Title	Supplementary Report to the JRPP
JRPP Number	2011SYW087
Application Number	DA-1210/2011
Proposed Development	Demolition of existing structures and construction of a residential flat building comprising fifty-one residential units and two levels of basement car parking with vehicular access to be provided from Campbell Street and associated landscaping and service features.
Property Description	Part Lot 1 DP 1053951, Part Lot 2 1053951 93-95 Campbell Street Liverpool NSW 2170
Applicant	Gelder Architects
Land Owner	Talbus Pty Ltd
Capital Investment Value	\$11,000,000
Recommendation	Refusal

This supplementary report is prepared in addition to Council's principal report which was prepared for the consideration of the Sydney West Joint Regional Planning Panel at its meeting on 19 April 2012. It is noted that this principal report recommended the refusal of the application based on a number of design issues and non compliances with SEPP 65 provisions.

Figure 4: Extract of Landscape Plan

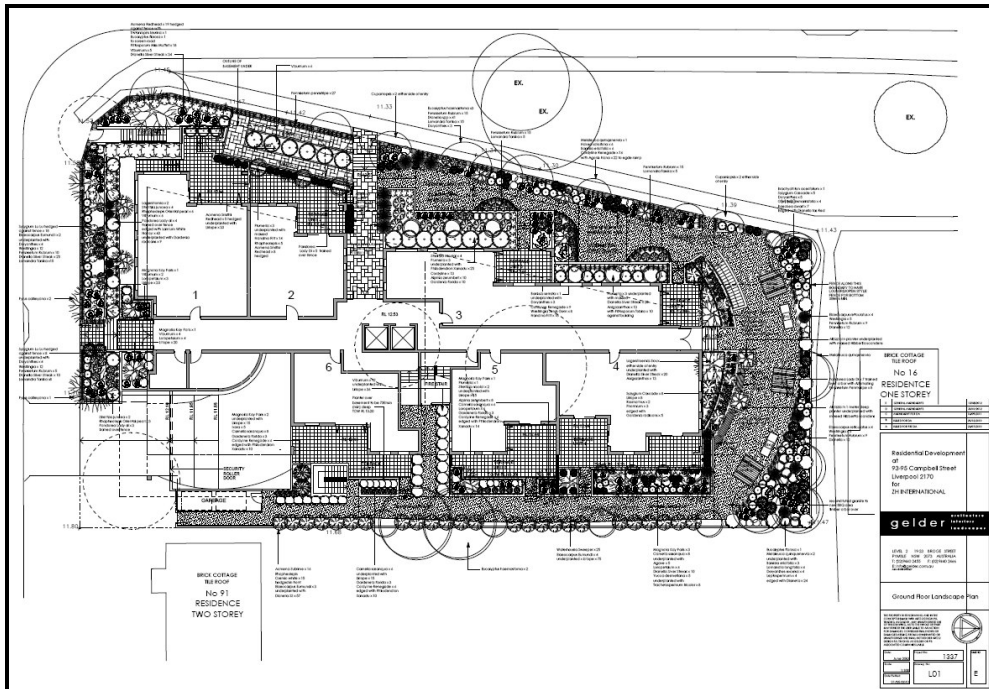
The amended proposal is accompanied by a detailed landscape plan which provides for improved resolution of private and public areas within the development site. The landscape plan also improves the amenity for future occupants of the site through ensuring courtyards are private and has also incorporated embellishments to communal open space such as seating, bbq areas and dining areas.

Figure 6: Amended Landscape Plan

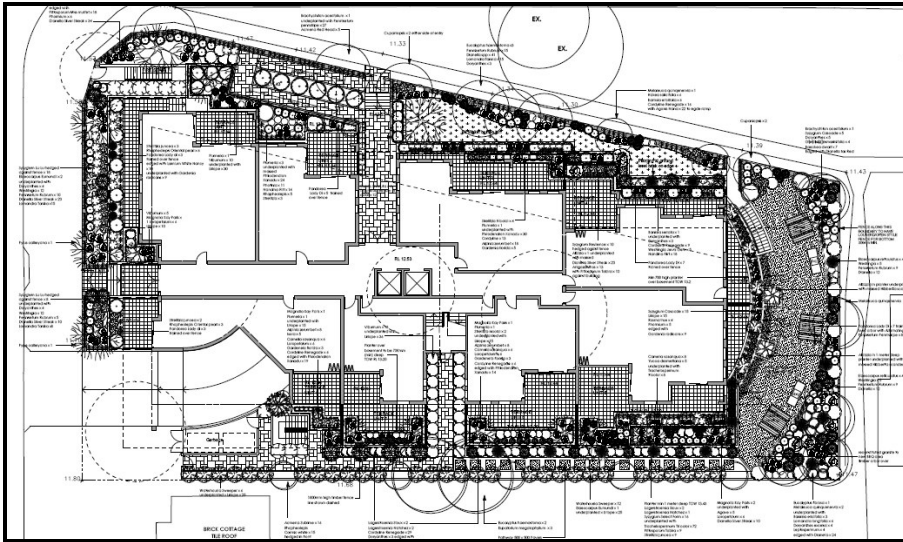
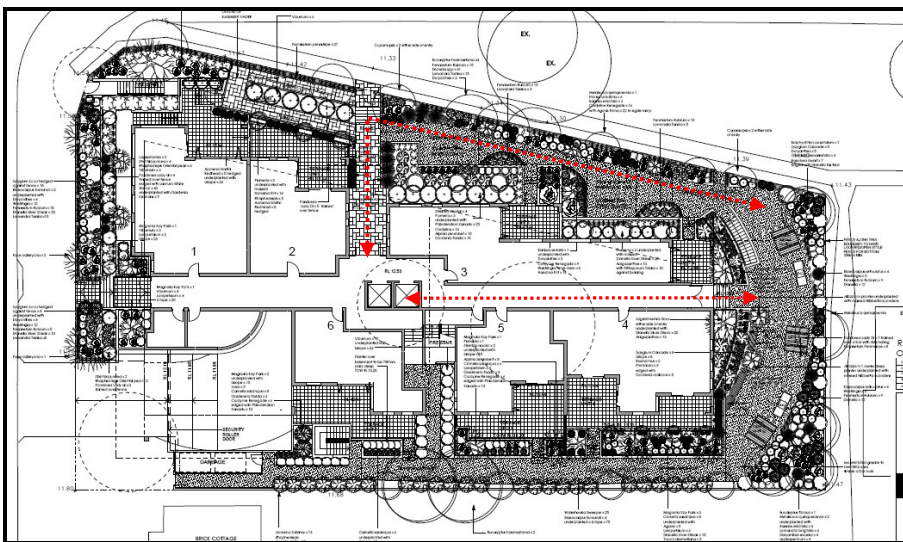
An important change has been the provision of a direct link to the communal open space from the service core of the development. This is illustrated in an extract of both the original and amended landscape plan below.

Increased communal space at the eastern boundary of the site providing a link to primary common open space

Improved linkage to primary communal open space from service core

It is considered that the amended proposal resolves the concerns raised by the DRP in regards to the communal open space provided for the development. The following comments are made in response to the DRP concerns:

As outlined above the proposal has been amended to provide a link from the service core of the development to the communal open space located adjacent to the northern boundary of the site. The proposal as amended provides a useable area adjacent the northern boundary with minimum dimensions of 22 metres by 5 metres which has been embellished with outdoor furniture and bbq areas.

Figure 7: Extract of Ground floor plan (adjacent eastern boundary)

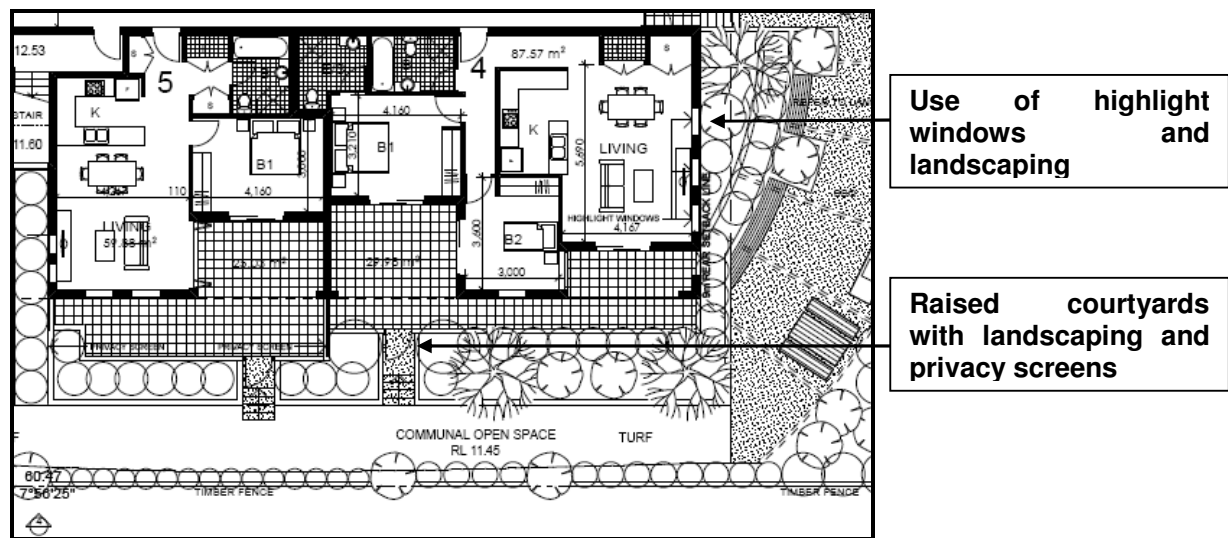
The amendments have also resulted in the internal active uses such as living areas and courtyards being located adjacent communal open space. The courtyards adjacent areas designated as communal open space have also been terraced and embellished with greater landscaping to provide a better definition of public and private open space.

These amendments to the plans are highlighted in Figures 7 and 8 below.

Given the above, it is considered that the proposal as amended has satisfied the concerns raised by the DRP in relation to any impacts of the communal open space area and privacy within the development.

Figure 9: Extract of Figure 3 of LDCP 2008 Part 4.

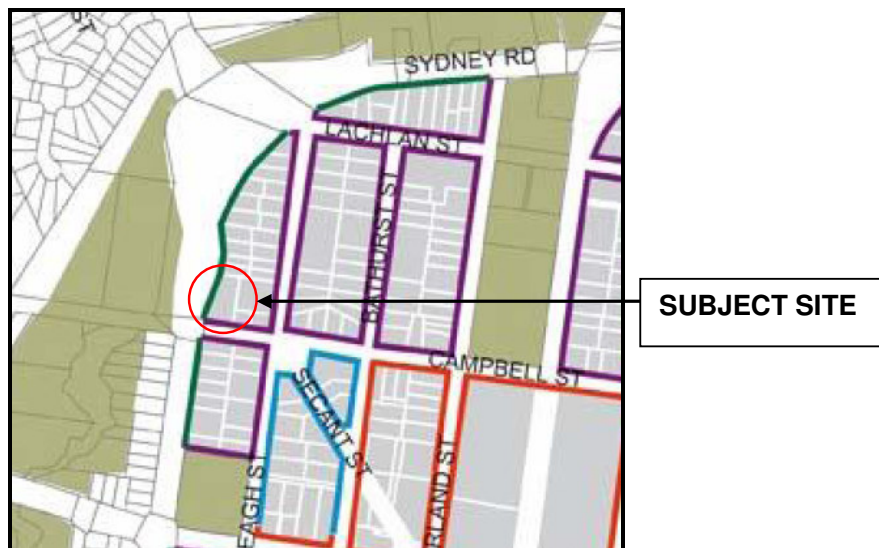
Controls have been provided within Part 4 of LDCP 2008 which nominates street building alignment and street setback controls. The controls require a street building setback of 8m for sites with a frontage to Copeland Street/Hume Highway as illustrated within Figure 3 of LDCP 2008.

Despite the amendments to the proposal, the development does not comply with this control. The applicant has put forward the following submission in relation to this non-compliance with the LDCP 2008:

- a. The proposal does not provide for a 8m street alignment and setback to Copeland Street (Hume Highway) as required by Figure 3 of Liverpool Development Control Plan 2008 Part 4 – Development in Liverpool City Centre.

Figure 10: Extract of ground floor plan with 8m setback

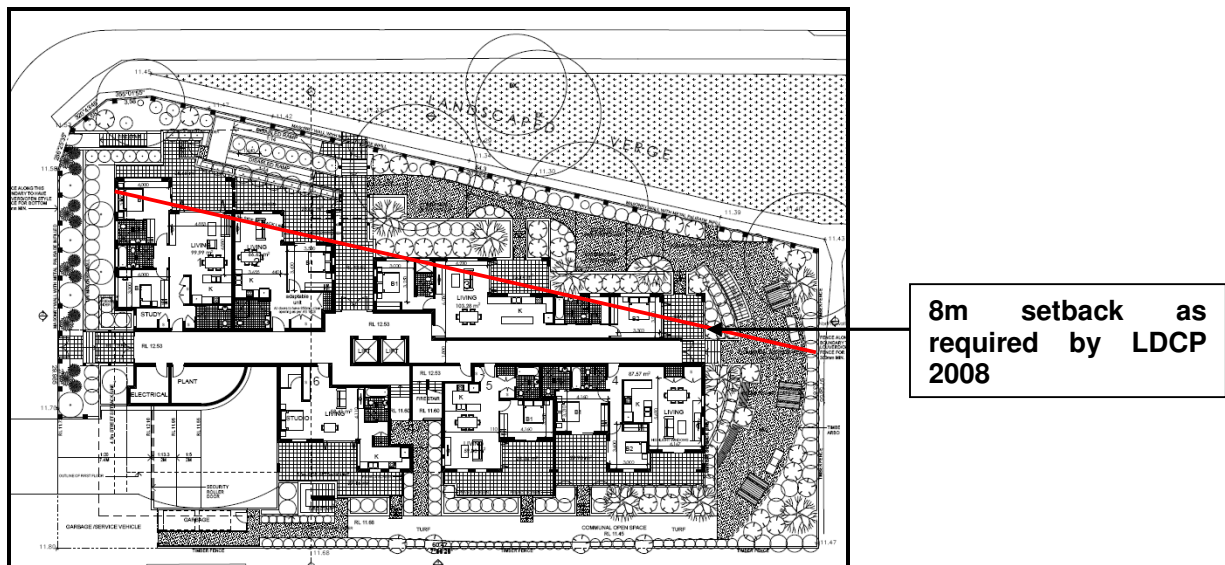
The applicant has identified on the ground floor plan which is provided in Figure 10 below the extent of the 8m setback from Copeland Street/Hume Highway.

Despite the amendments to the proposal, the development still results in a substantial non compliance with the street alignment and setback controls prescribed by LDCP 2008. It is considered that this non compliance is not acceptable and that the 8m setback should be complied with.

The submission put forward by the applicant that the location of the “landscaped verge” immediately adjacent the sites frontage to Copeland Street/Hume Highway should be relied upon is not considered appropriate. This borrowed amenity from the existing verge within the road reserve should not be relied upon as a landscaped area or in regards to a physical separate between the subject site and the road reserve.
